VAN BUREN COUNTY
JOE PARMAN, DRAIN COMMISSIONER

DAM INSPECTION REPORTS

APRIL, 2011

PROJECT NO. 9527-6

GREAT BEAR LAKE

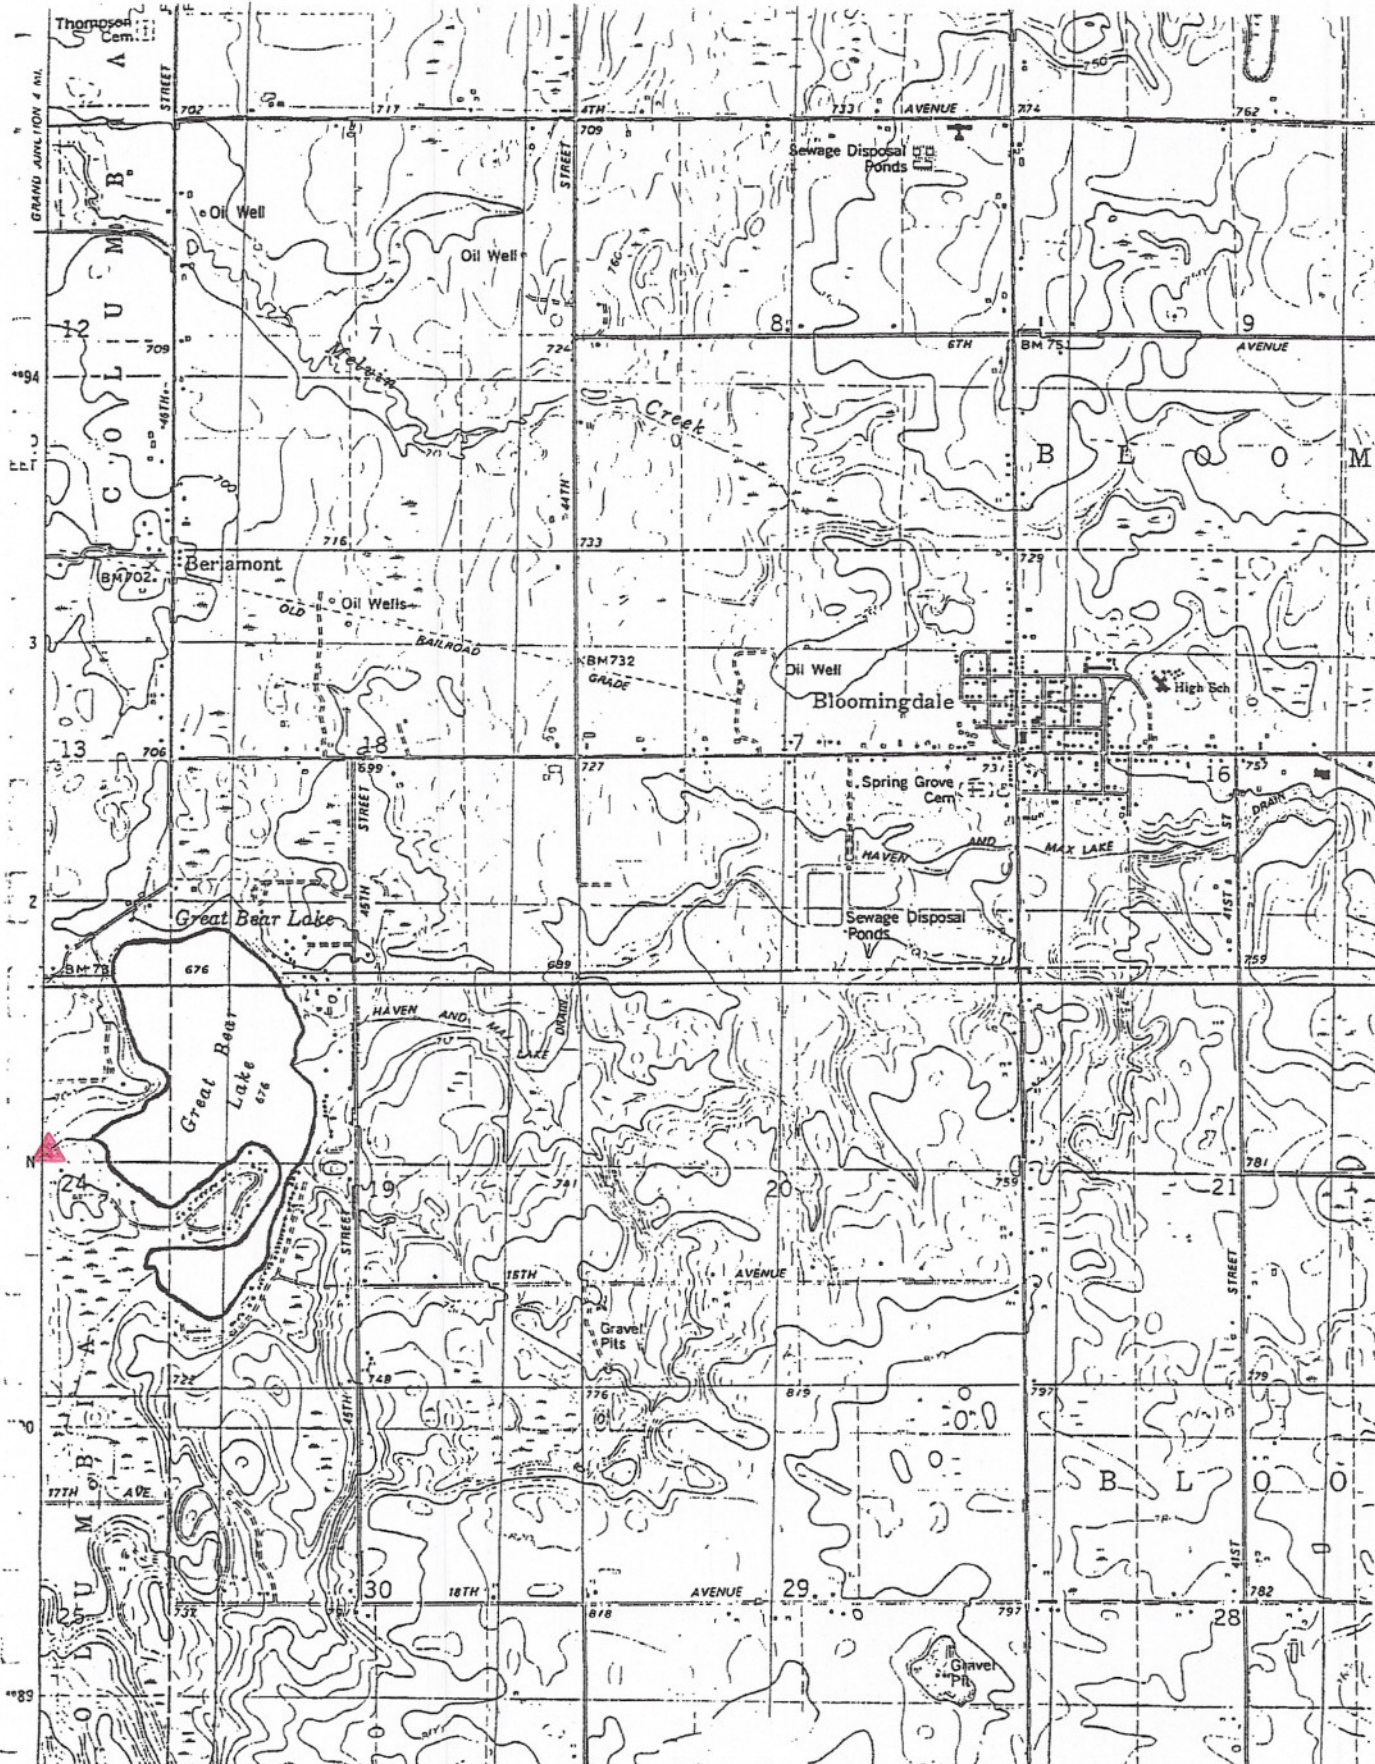
Stoplogs in fish ladder were submerged during inspection. Past report indicated they were in fair to poor condition.

Brush and trees growing in and around fenced fish ladder area and should be removed and stumps treated with herbicide.

The area inside the fenced area is overgrown with brush and trees. These should be removed and stumps should be treated with herbicide.
